PRELIMINARY OVERALL AREA DEVELOPMENT PLAN
FOR
UNIVERSITY BUSINESS PARK UNIT - 1

INFORMATION SHEET FOR
PRELIMINARY OVERALL AREA DEVELOPMENT PLAN
(P.O.A.D.P.)

Re: University Business Park Preliminary Plan
 P.O.A.D.P.
File #: 84-12-62-86

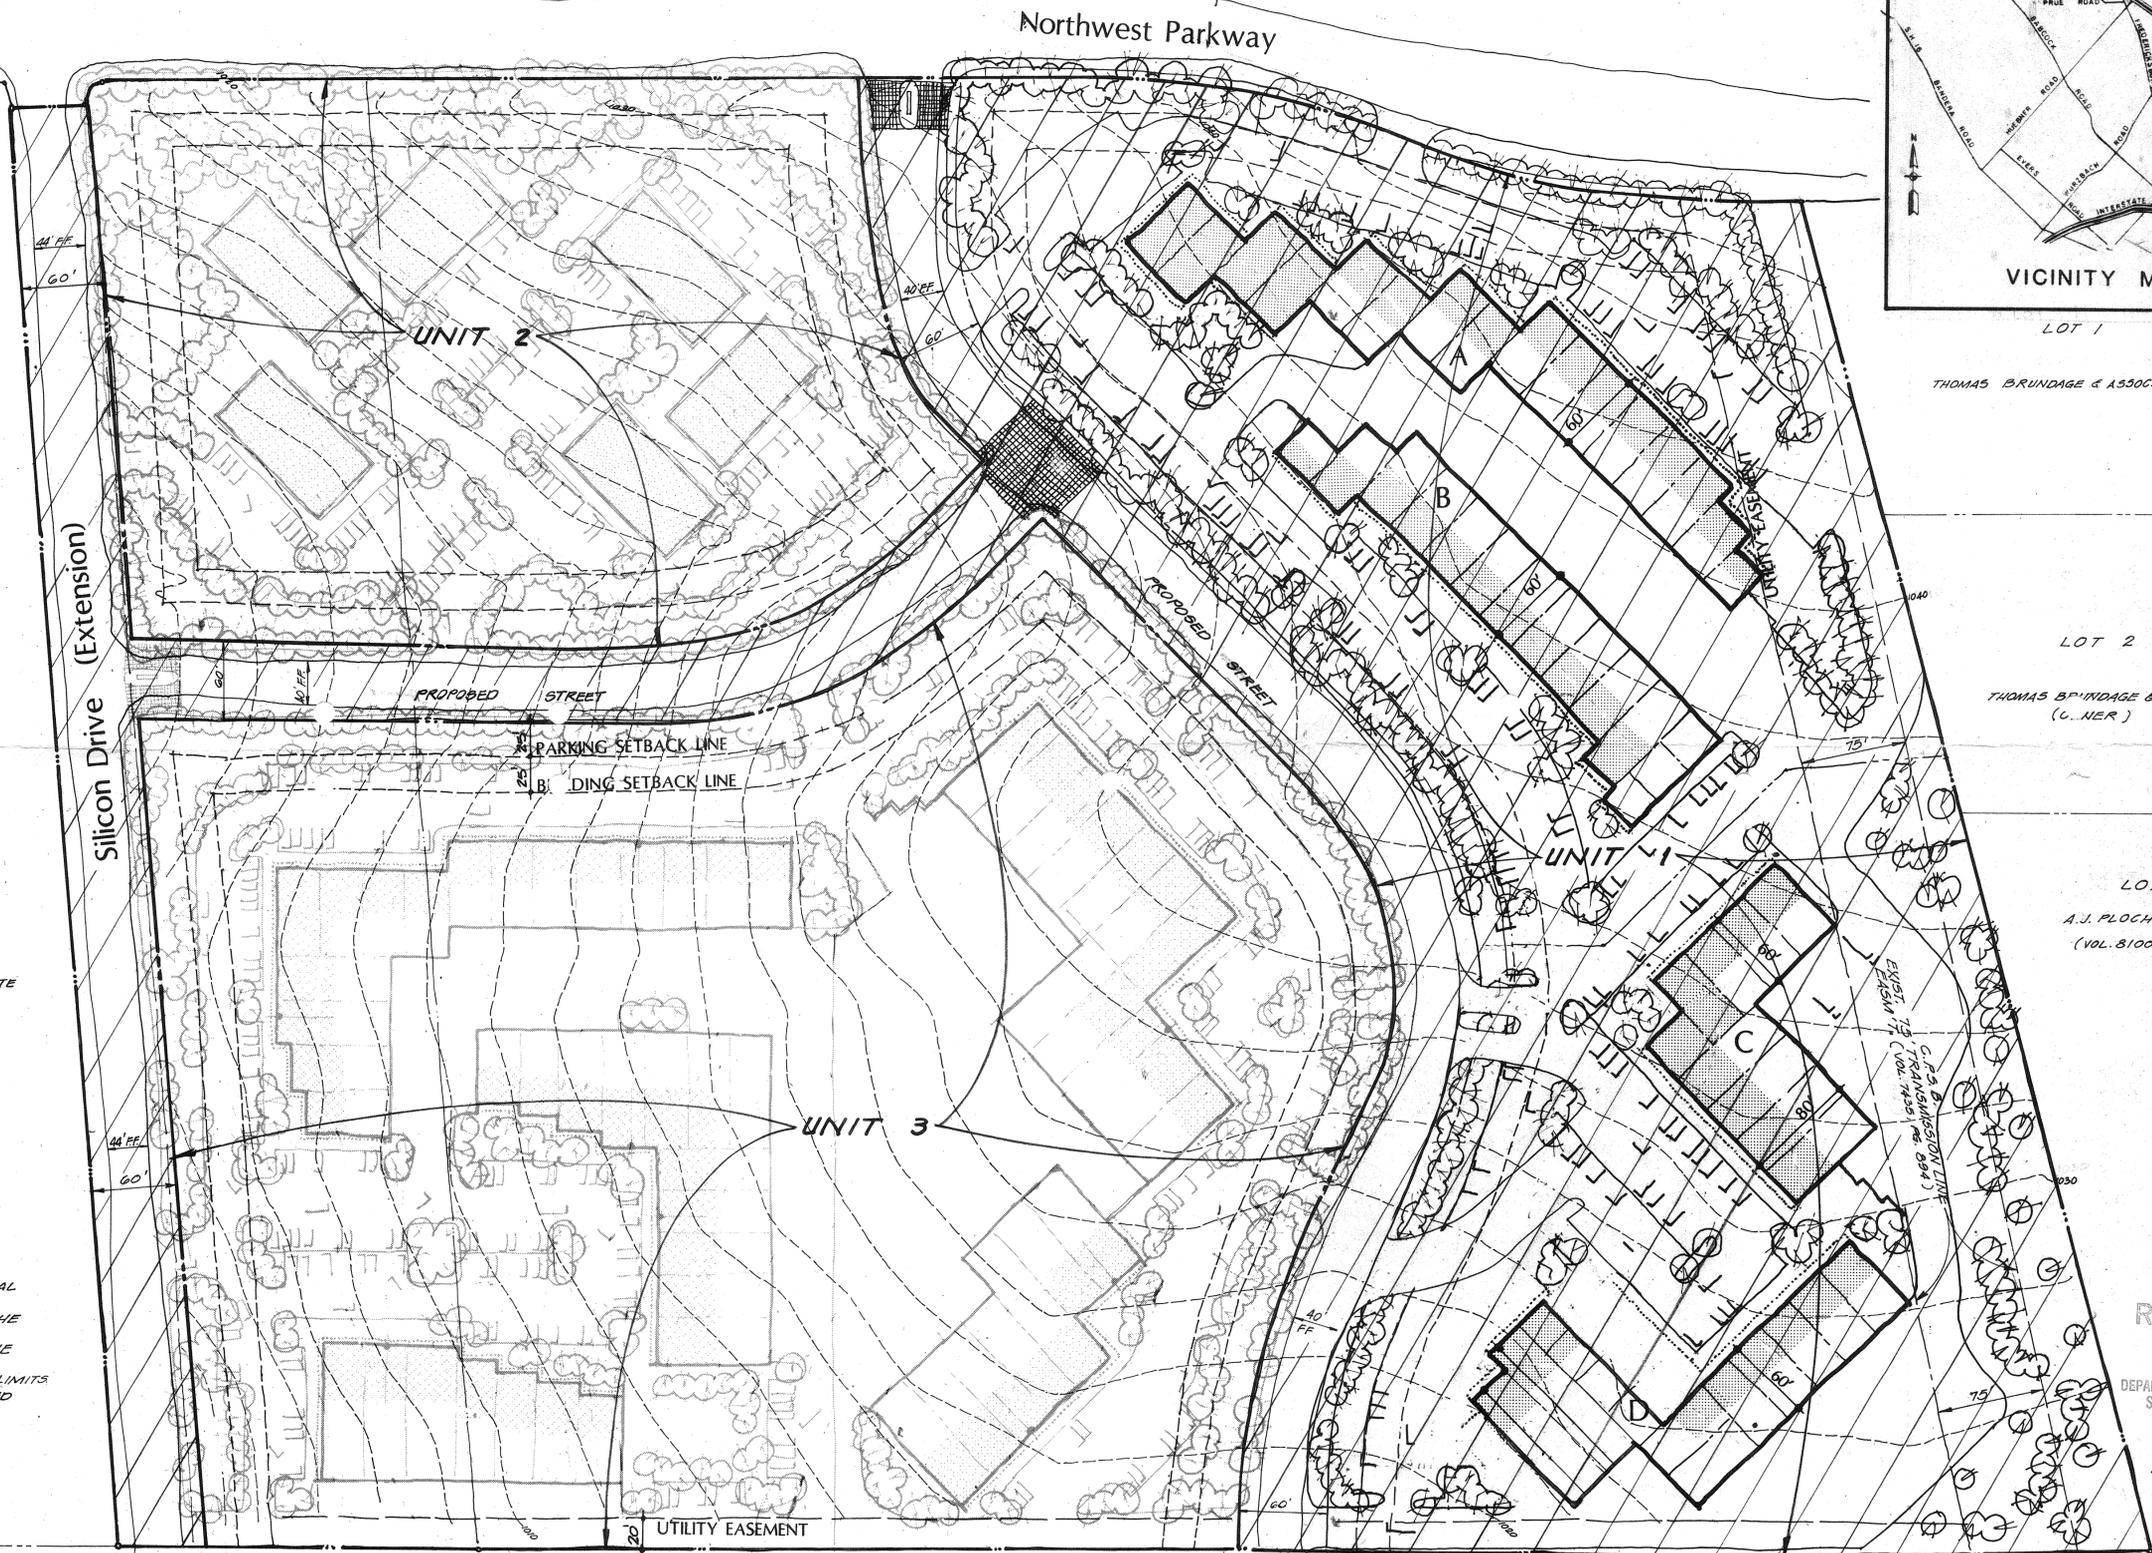
| <input type="checkbox"/> Street jogs or intersections | <input checked="" type="checkbox"/> <u>Sec. 36-10(M)(1)(a)</u> |
| <input type="checkbox"/> Dead-end streets | <u>Pavement width & R.O.W.</u> |
| <input type="checkbox"/> Cul-de-sac streets in excess of 500' | <u>width.</u> |

- See annotations/comments on attached copy of your plan.
- Comments: See attachment regarding the recommended upgrading of the proposed north-south local type "B" street.

It will be necessary to upgrade the proposed north-south local type "B" street to a collector status. This provision will facilitate expected traffic volume in the area. Although staff poses no objections to the street alignments as planned, it is recommended that you work with the adjacent property owner to the southeast in effort to coordinate an alignment that will allow an easterly linkage with I.H. 10. Silicon Drive also calls for coordination with the adjacent property owner to the south.
